Description of Work/Use: RADIO TOWER CONSTRUCT 80' AGL RADIO TOWER FOR O.C. GOVT USE (NO CELLUAR)
FREE-STANDING (SELF-SUPPORTING) TOWER

TITLE
Ocean County New Jersey
Radio Communication Tower:
Forge Pond Golf Course, Brick Township
LTW ID/Call Sign - Site #9

TOWNSHIP OF BRICK
APPLICATION REVIEW PROCESS

TO: Frank Miser
FROM: Rich Maloney
DATE: 04/19/2006
RE: Brick Township Tower

Plan View

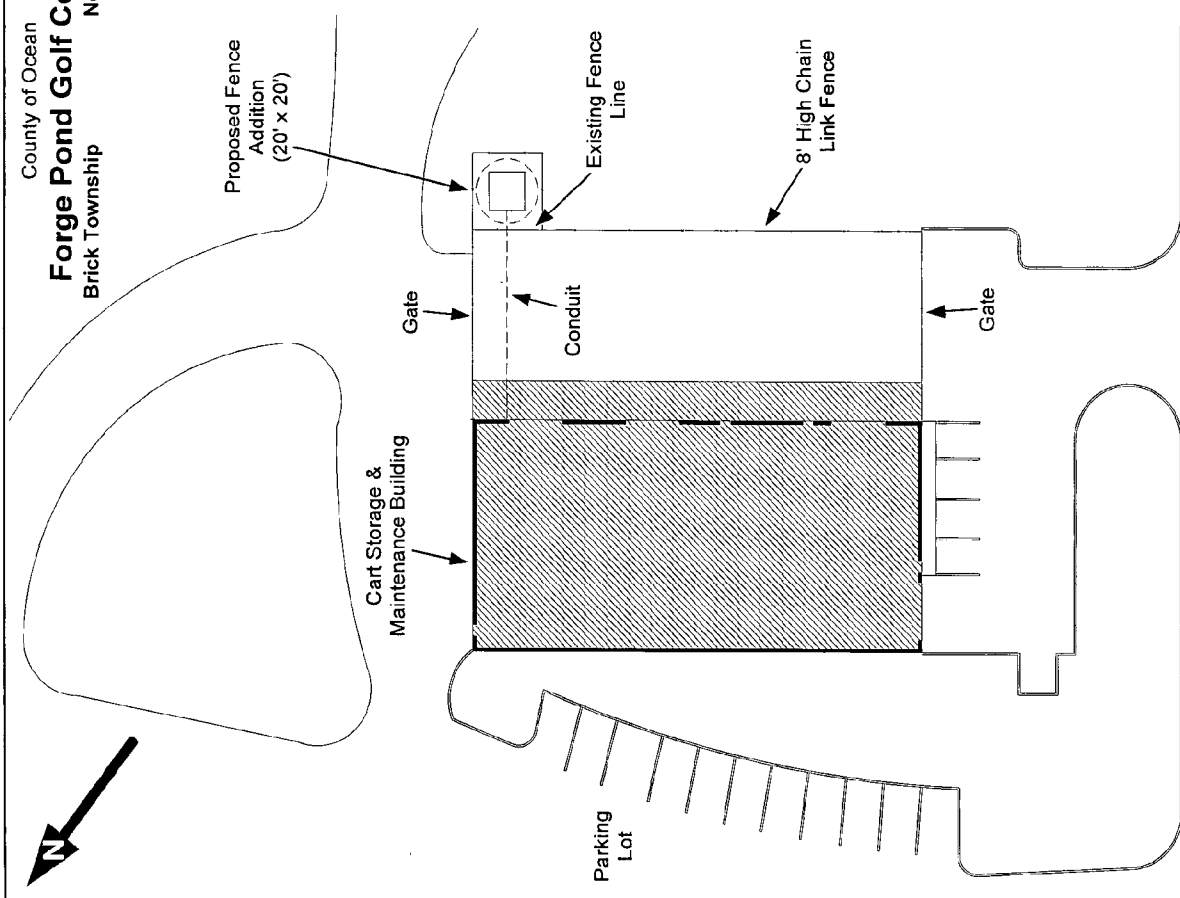
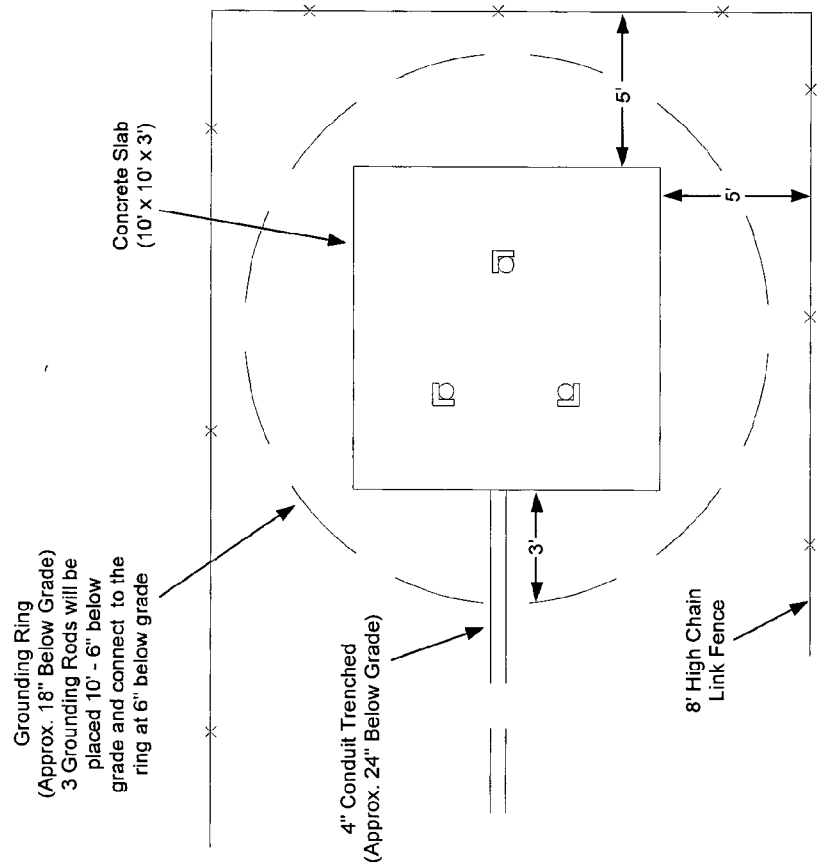
① IBC Notes 3-second gust wind speed is AT 33' Tower is 81'-2" A.G.

② IBC Section 3108.4 Notes E1A/T1A 222-E US F AS

Noted on plan, please explain

③ was ICC loading factored in?

④ How do tower sections fasten together?

⑤ No fabrication drawings submitted

⑥ Supply all calculations, loads?
